Addendum

Iowa Department of Transportation Date of Letting: October 20, 2015

B.O.	Proposal ID	Proposal Work Type	County	Project Number	Addendum
103	97-0201-133	PCC PAVEMENT - GRADE AND NEW	WOODBURY	NHSX-020-1(130)3H-97 NHSX-020-1(133)3H-97 NHSX-020-1(147)3H-97 NHSX-020-1(149)3H-97 NHSX-020-1(170)3H-97	200CT103.A02

Make the following change to the plans: NHSX-020-1(130)--3H-97

WOODBURY COUNTY IOWA DEPARTMENT OF TRANSPORTATION - HIGHWAY DIVISION DESION SHEET NO. 3 OF 36. FILE NO. 30568. DESION NO. 114

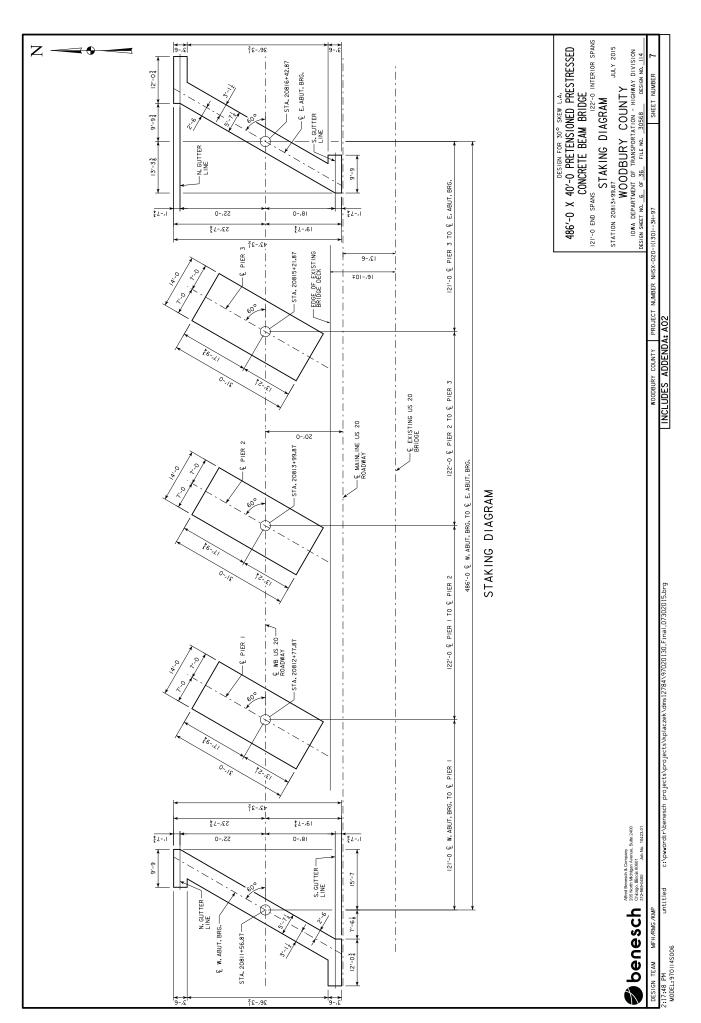
Sheet No. 4

- 1. Under the Specifications Notes Replace the reference of The Iowa Department of Transportation Standard Specifications For Highway and Bridge Construction from Series 2012 to Series 2015.
- 2. Change the Developmental Specification Number for "Developmental Specifications for Mass Concrete Control of Heat of Hydration" from DS-12070 to DS-15032.
- 3. Change the Developmental Specification Number for "Developmental Specifications for High Performance Concrete for Structures" from DS-12071 to DS-15033.

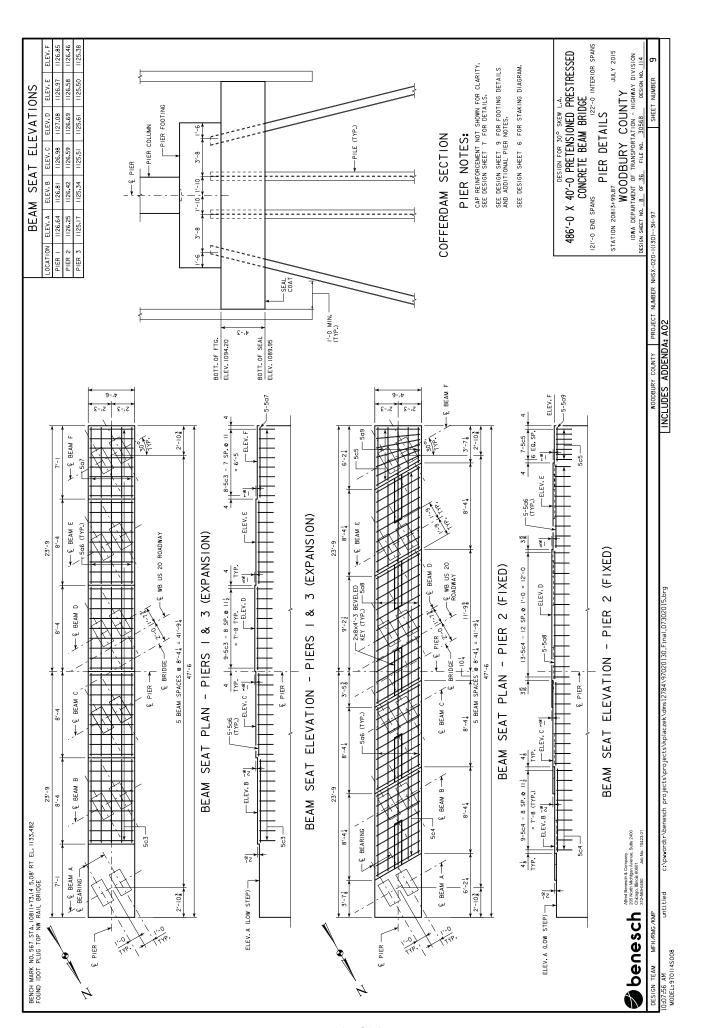
Sheet No. 7

- 1. Added the 13'-6" dimension between the centerline of the existing bridge to the centerline of Mainline US 20.
- 2. Added the 16'-10 +/-" dimension between the centerline of the existing bridge and the edge of the existing bridge deck.

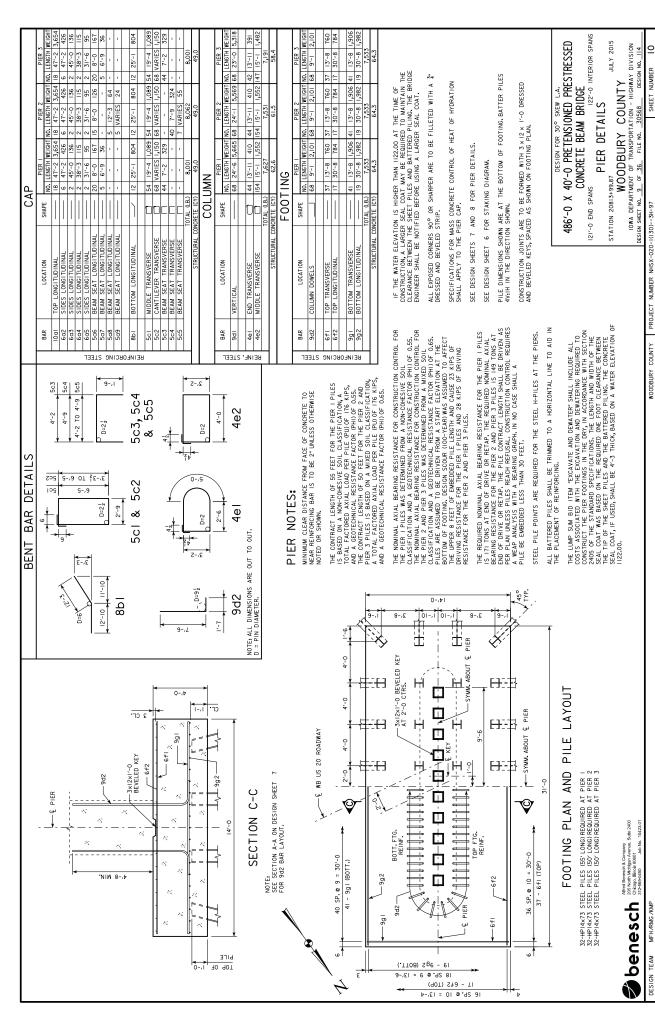
Sheet No. 9

- 1. In the Cofferdam Section, removed the dimensions between the edge of the footing and the outside edge of the seal coat.
- 2. In the Cofferdam Section, removed the 22'-0" width of the seal coat.

JULY 2015 WOODBURY COUNTY IOWA DEPARTMENT OF TRANSPORTATION - HIGHWAY DIVISION DESIGN SWEET NO. 3. OF 36. FILE NO. 30568. DESIGN NO. 214

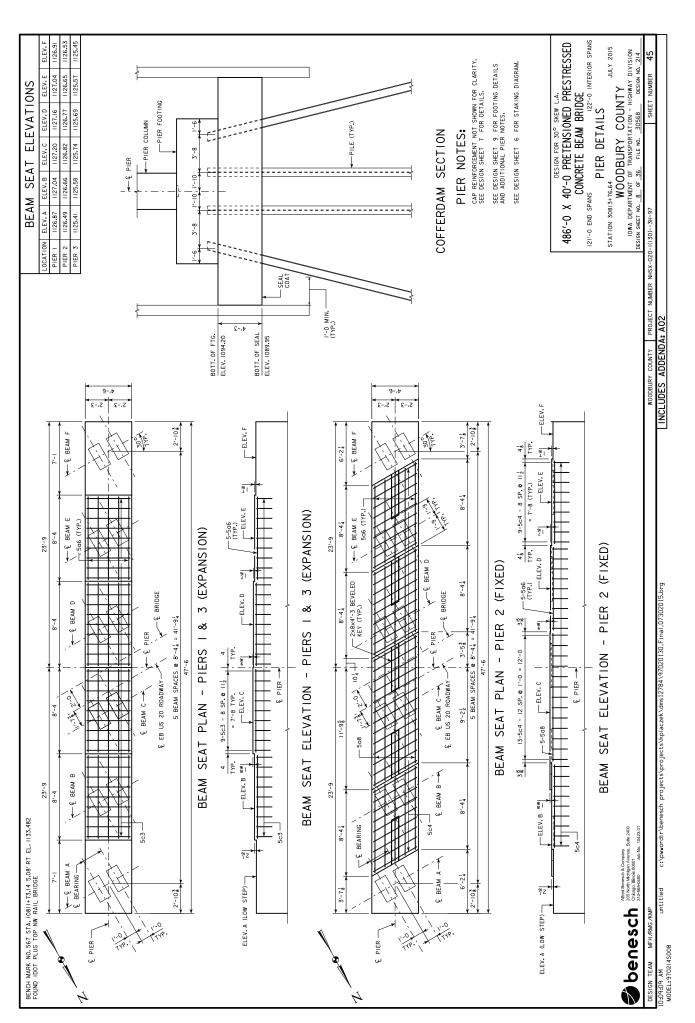
Sheet No. 40

- Under the Specifications Notes Replace the reference of The Iowa Department of Transportation Standard Specifications For Highway and Bridge Construction from Series 2012 to Series 2015.
- 2. Change the Developmental Specification Number for "Developmental Specifications for Mass Concrete Control of Heat of Hydration" from DS-12070 to DS-15032.
- 3. Change the Developmental Specification Number for "Developmental Specifications for High Performance Concrete for Structures" from DS-12071 to DS-15033.

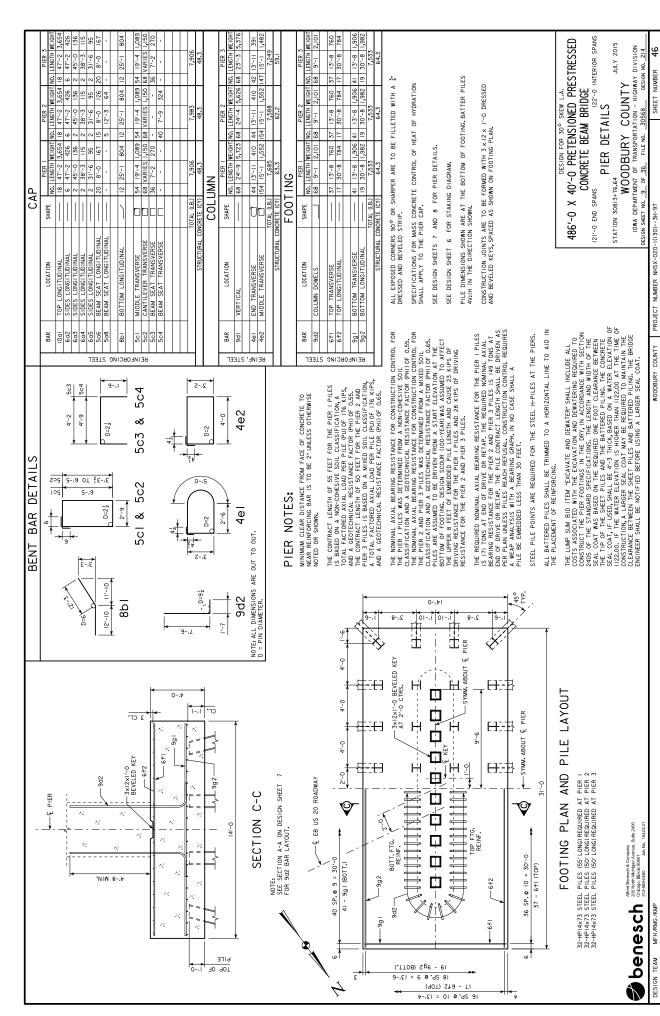
Sheet No. 45

- 1. In the Cofferdam Section, removed the dimensions between the edge of the footing and the outside edge of the seal coat.
- 2. In the Cofferdam Section, removed the 22'-0" width of the seal coat.
